Subject: Comment Letter – Once Through Cooling Policy Mitigation Fee Delegation Resolution

TECHNICAL MEMORANDUM

To: Ms. Katherine Rubin, LADWP
Cc: Mr. Shane Beck, MBC Applied Environmental Sciences
Mr. Eric Miller, MBC Applied Environmental Sciences
From: John Steinbeck, TENERA Environmental
Subject: Comments on recent mitigation fee proposal from SWRCB
Document: ESLO2015-13

Figure 1. Model of restoration gains with monitoring over the life of the project. Only the gains in green are accounted for in the approach presented in the 2015 Proposal.

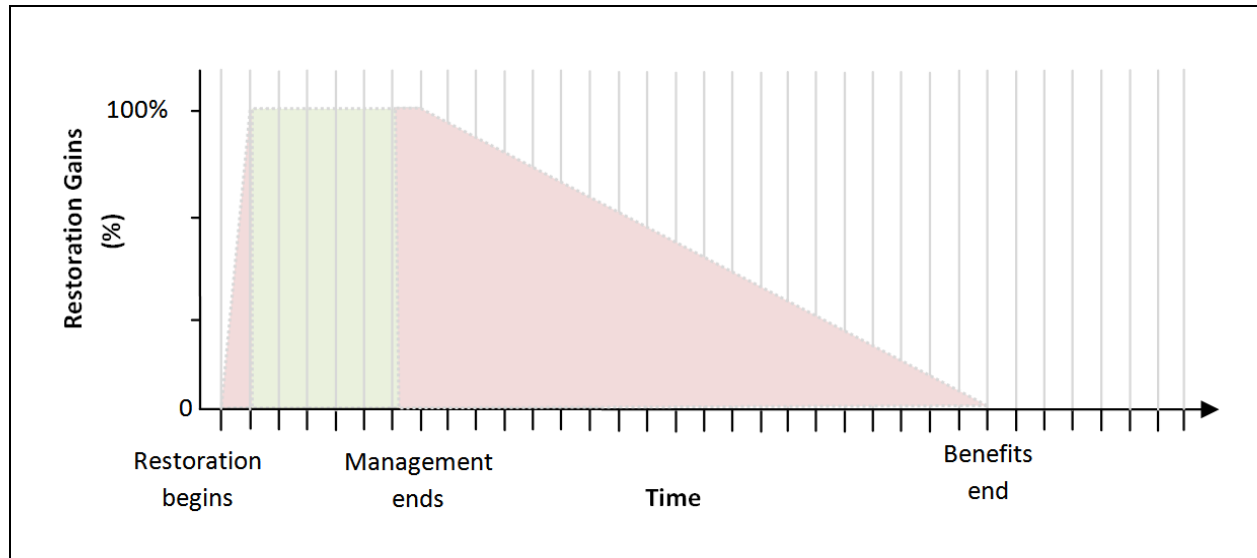
In its current form, the approach does not provide any accommodation for the time value of the project. For example, if the life of a project is 100 years, the total value of \$1 in mitigation at the start of a project will provide with a discount rate of 3% over \$30 dollars in benefits (value). In actuality, with 3.0% discounting, it will take several hundred years before the value approaches zero. Conversely, the cost of completing the same mitigation project would increase over time. If the inflation rate is assumed to equal the discount rate, the Estimated Costs at Time of Projection would be divided by the projected years of the project impacts to determine an annual cost. As noted above, this will be project dependent. The methodology does not account for the continued value of the project that could extend out over several decades (100 years in the 2012 Proposal).

This interpretation of the fee ties into the second assumption in the approach related to the costs of monitoring and management. For the 2012 Proposal, we assumed a cost of ~10% to cover management of the projects, although the final report included a range from 10–25% to cover the costs of monitoring the success of a project. The addition of this to the final costs is problematic since the facilities paying into the state fund will have no control over the success of the project. Therefore, this presents two scenarios. The first scenario is based on the approach provided in the 2015 Proposal where a markup is added to the cost to cover monitoring and management. This additional funding helps ensure that the mitigation project is providing 100% of the necessary benefits over the life of the intake (**Figure 1**). The second scenario would provide funding for the mitigation project which at the completion of construction would start declining in value (**Figure 2**). In both scenarios, the benefits need to include the time out to the effective life of the project (100 years in the 2015 Proposal).
